**Planning & Zoning Commission
Agenda
Wednesday, May 17, 2023, 7:00 p.m.
Kirkwood City Hall
139 S. Kirkwood Road
Kirkwood, MO 63122
Posted May 12, 2023**

TO: PLANNING & ZONING COMMISSION
FROM: AMY LOWRY, CITY PLANNER II *AGL*
SUBJECT: 300 N. KIRKWOOD ROAD – KIRKWOOD APARTMENTS
DATE: MAY 17, 2023
CC: JONATHAN RAICHE, PLANNING & DEVELOPMENT SERVICES DIRECTOR
BILL BENSING, PUBLIC SERVICES DIRECTOR

ACTION REQUESTED: B-2, MIXED-USE DEVELOPMENT PLAN REVIEW

SUBJECT: PZ-1-24; 300 N. Kirkwood Road – Kirkwood Apartments
B-2 Mixed Use Final Site Plan

SITE UTILITIES PLAN
SCALE: 1"=10'

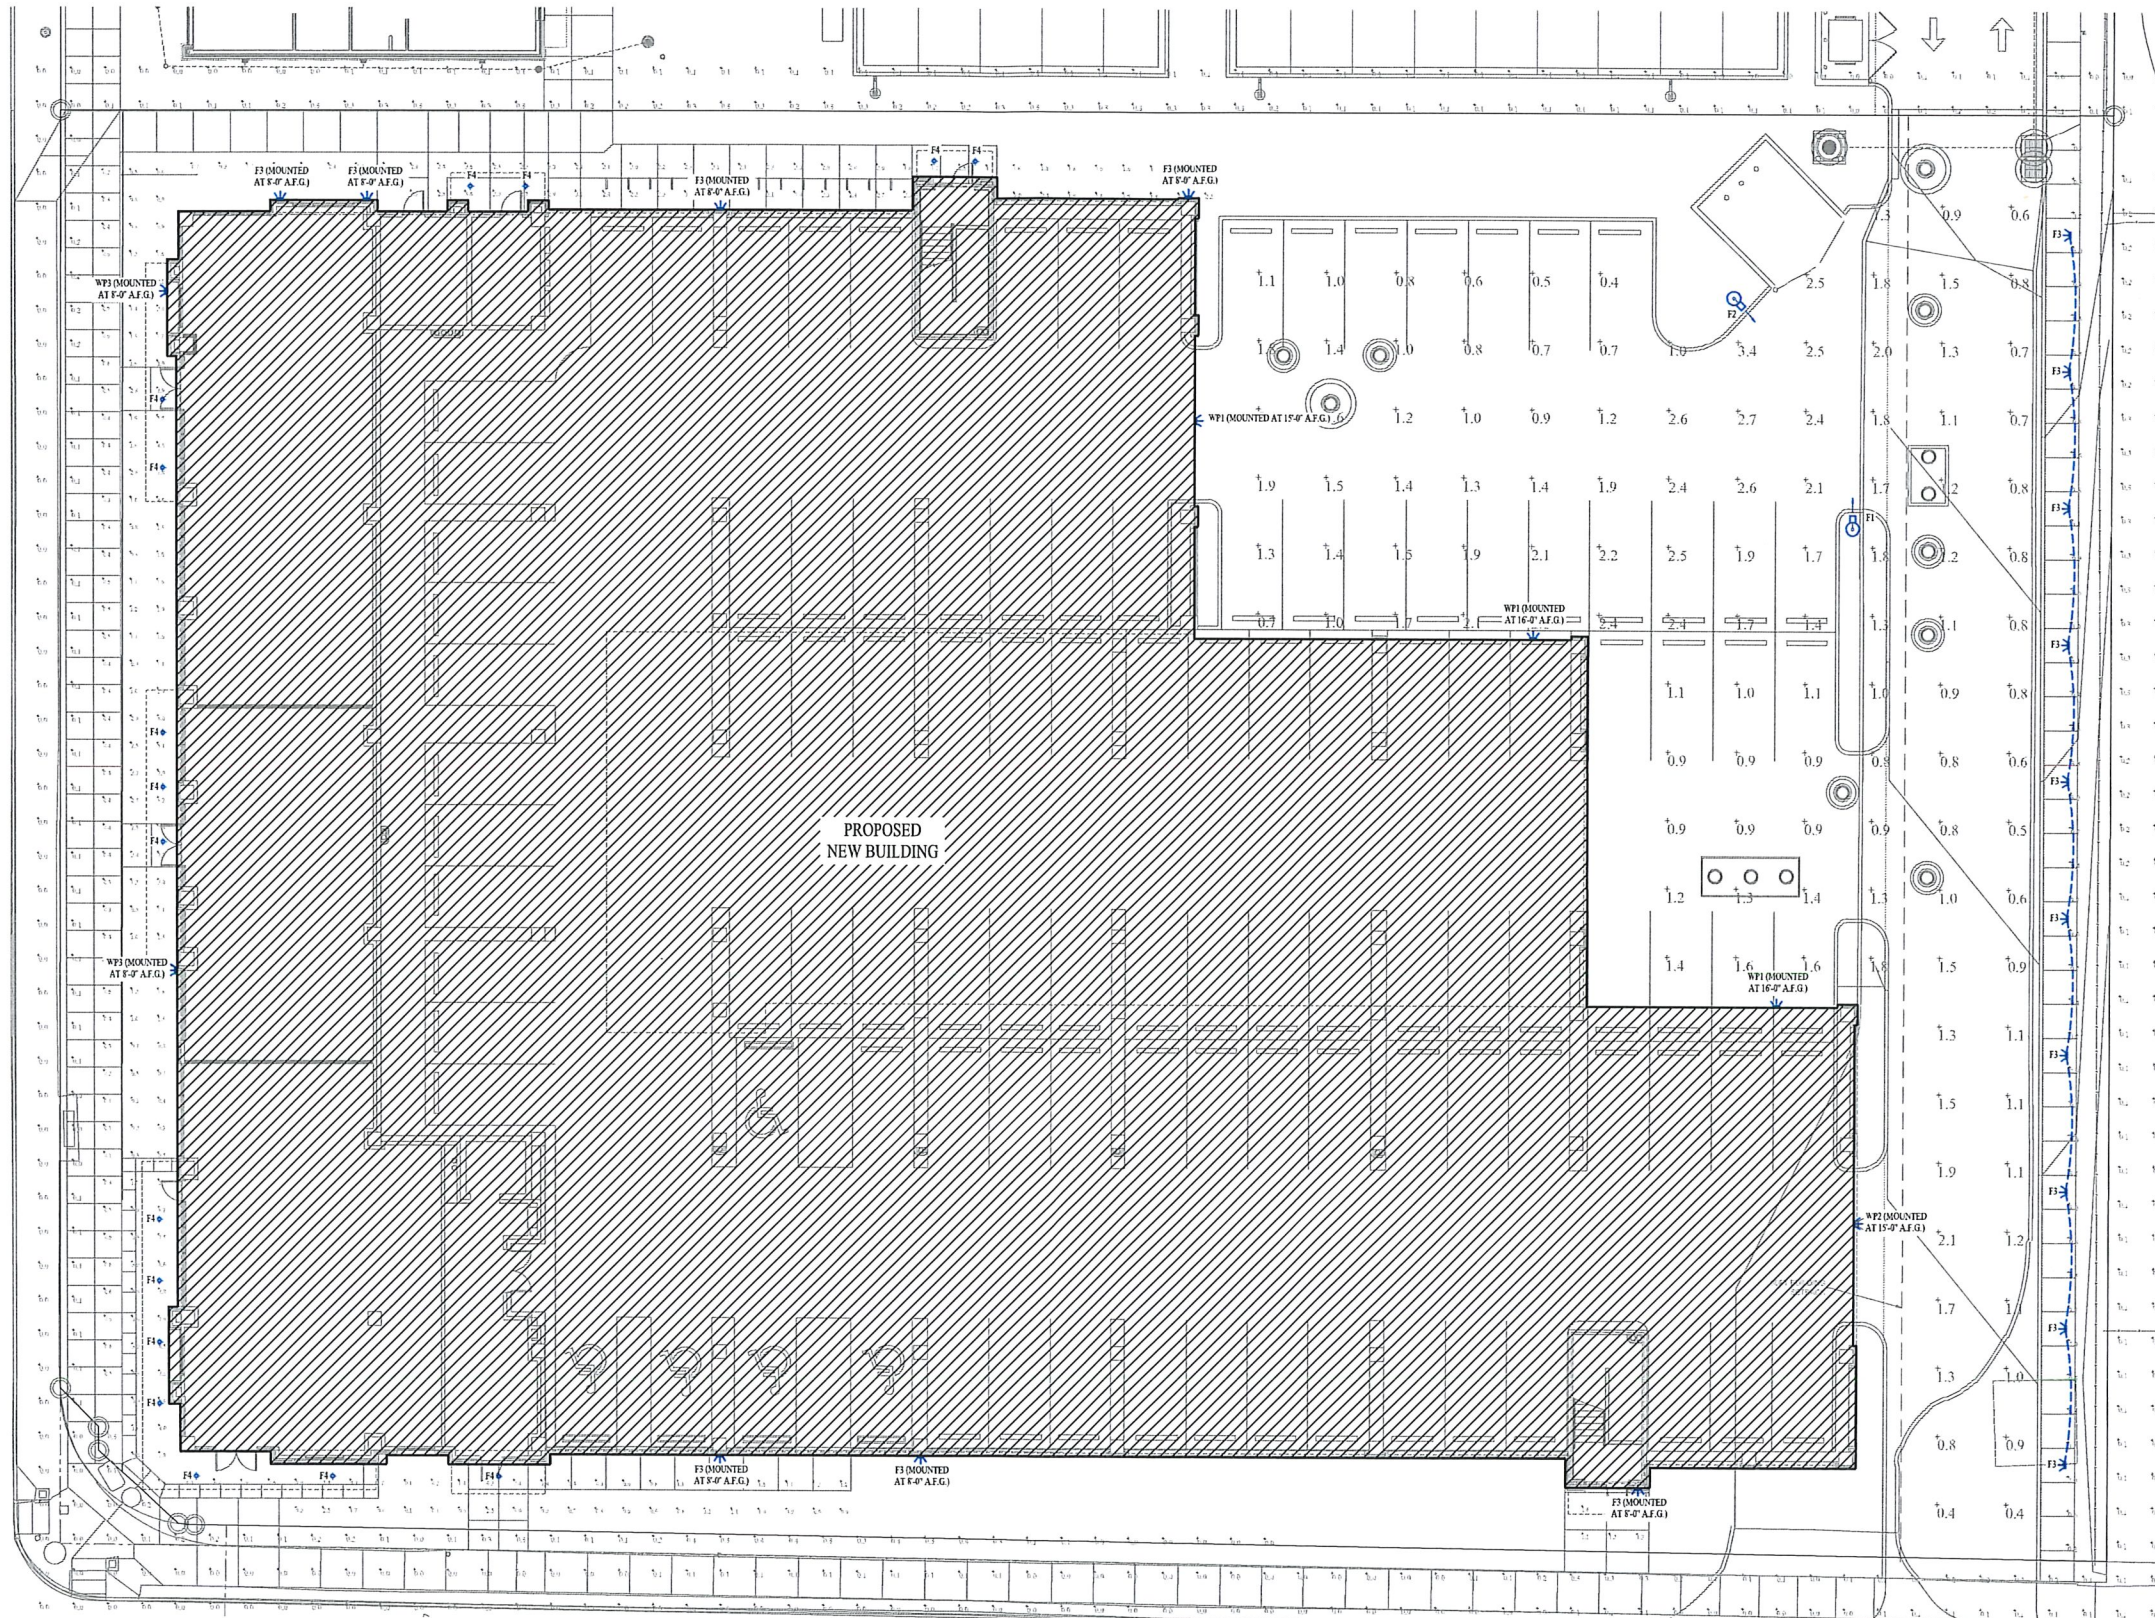
1. All light fixtures shall be installed in a downlight configuration.
2. Outdoor seating for the proposed restaurant greater than 12 seats will require a separate application and review by the Planning and Zoning Commission and City Council for a Special Use Permit that may result in additional restrictions for that specific use.
3. The parking analysis provided makes assumptions about the amount of square footage deducted for storage and other similar areas. Each tenant space will be evaluated at the time building permits are submitted for those specific spaces. While the proposed calculations with the referenced assumptions meet the code, approval of this plan does not guarantee parking will be met if the assumptions are not realized.

Sheet Title:	LANDSCAPE PLAN
Sheet No.:	L101
Date:	9/2/22
Job #:	813.101

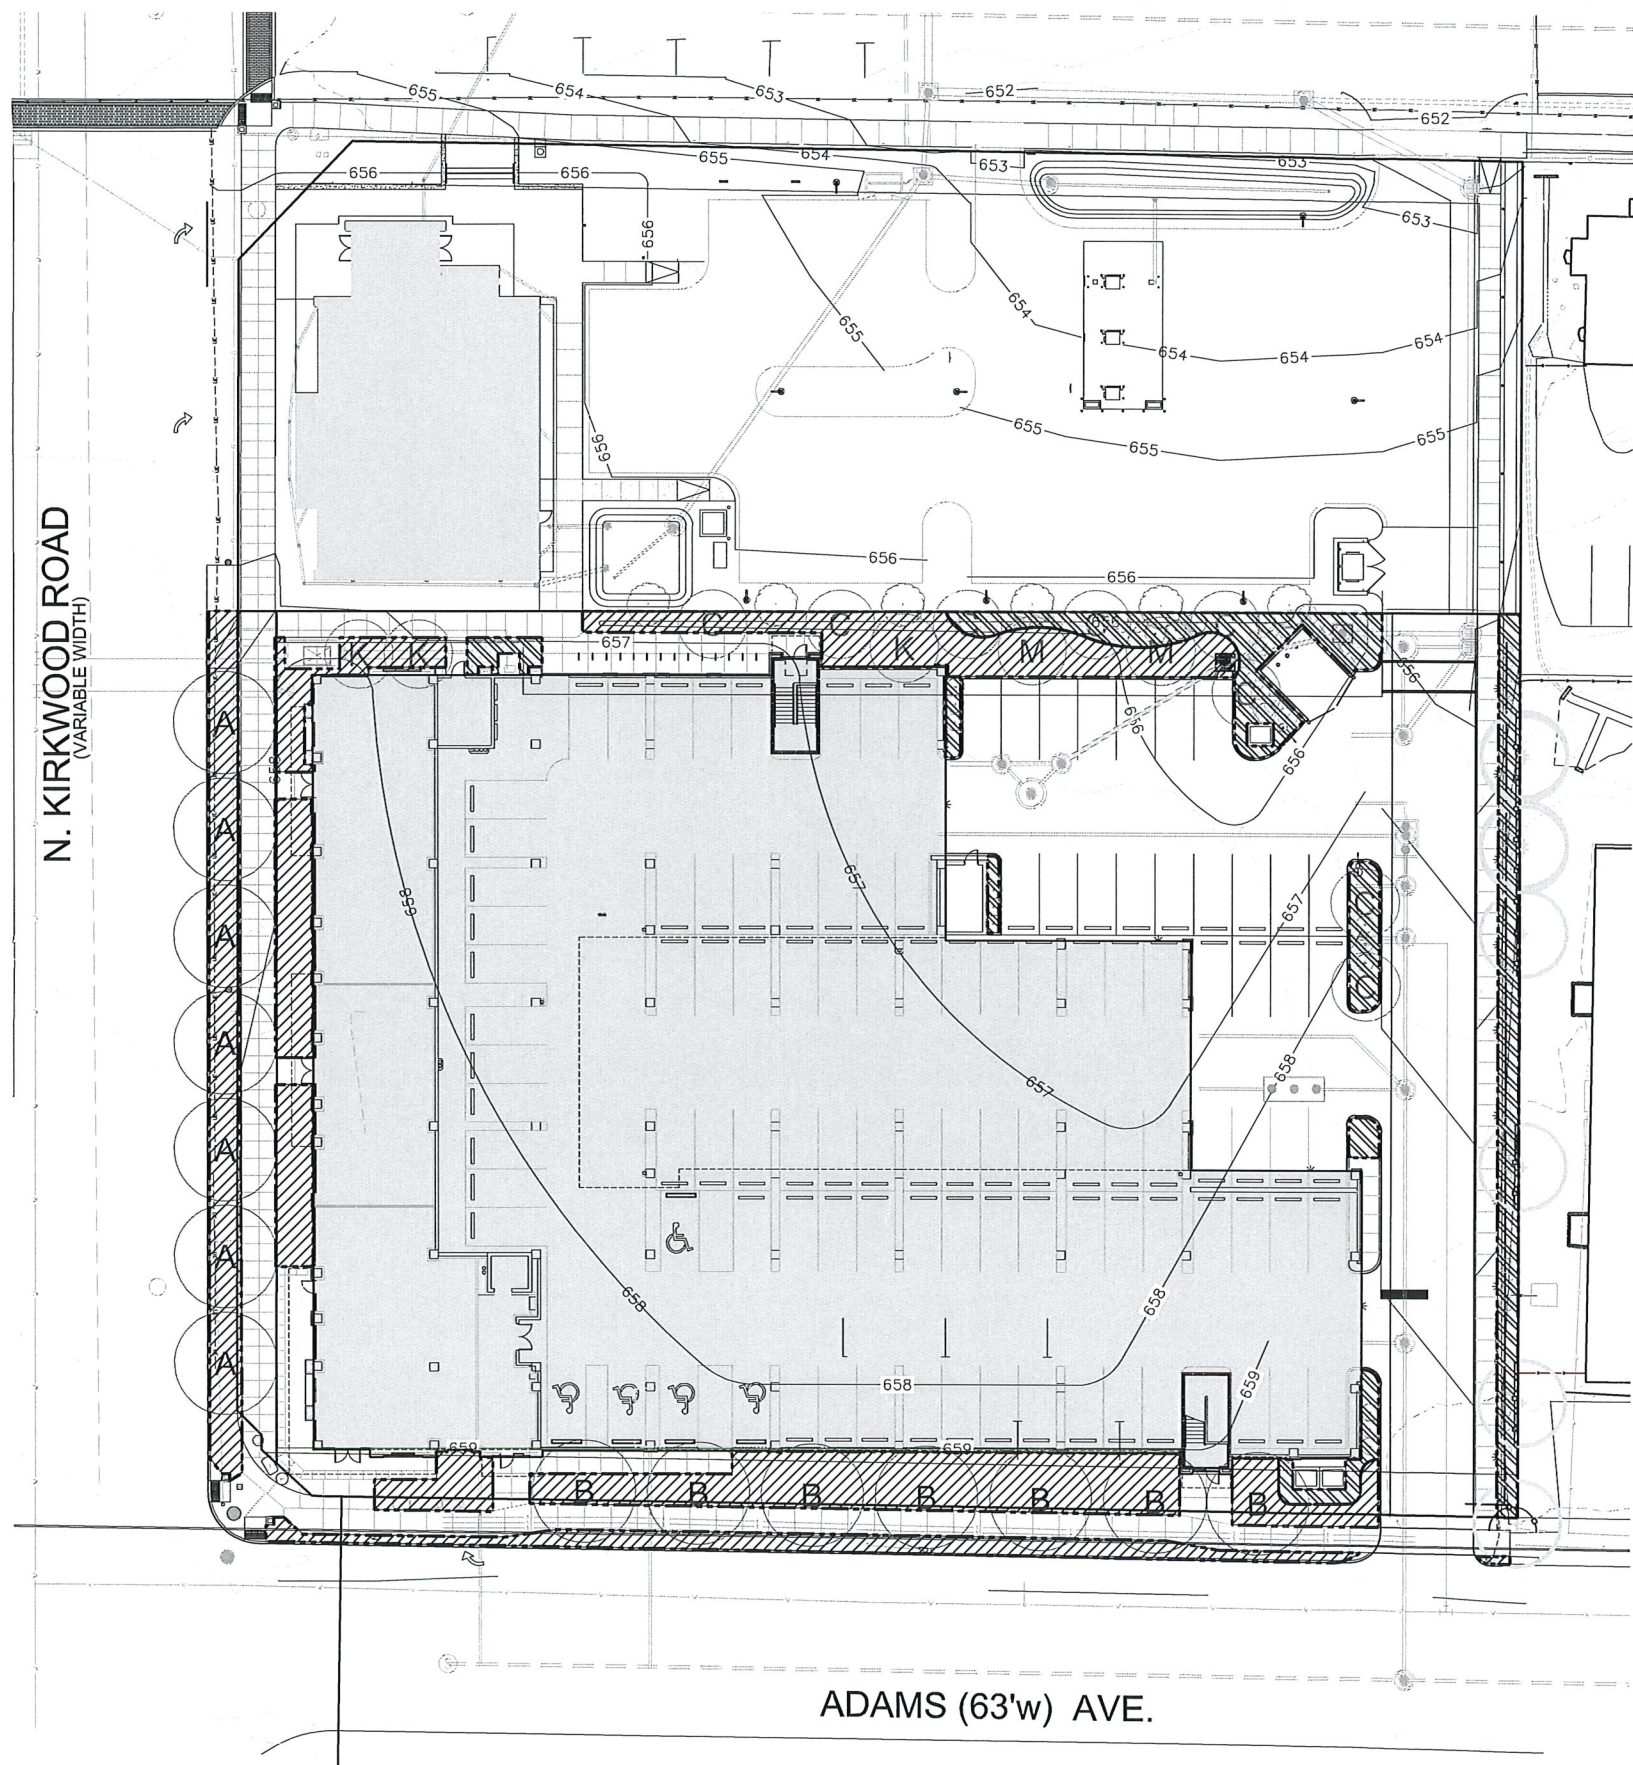
The landscape plan is slightly changed with one canopy tree omitted on the north side of the property, but with six canopy and five understory trees to remain there; no trees are required on the north, but Staff believes the additional proposed trees are appropriate and encourages their retention. An irrigation plan was provided with the updated landscape plan. The lighting plan still complies with the lighting regulations.
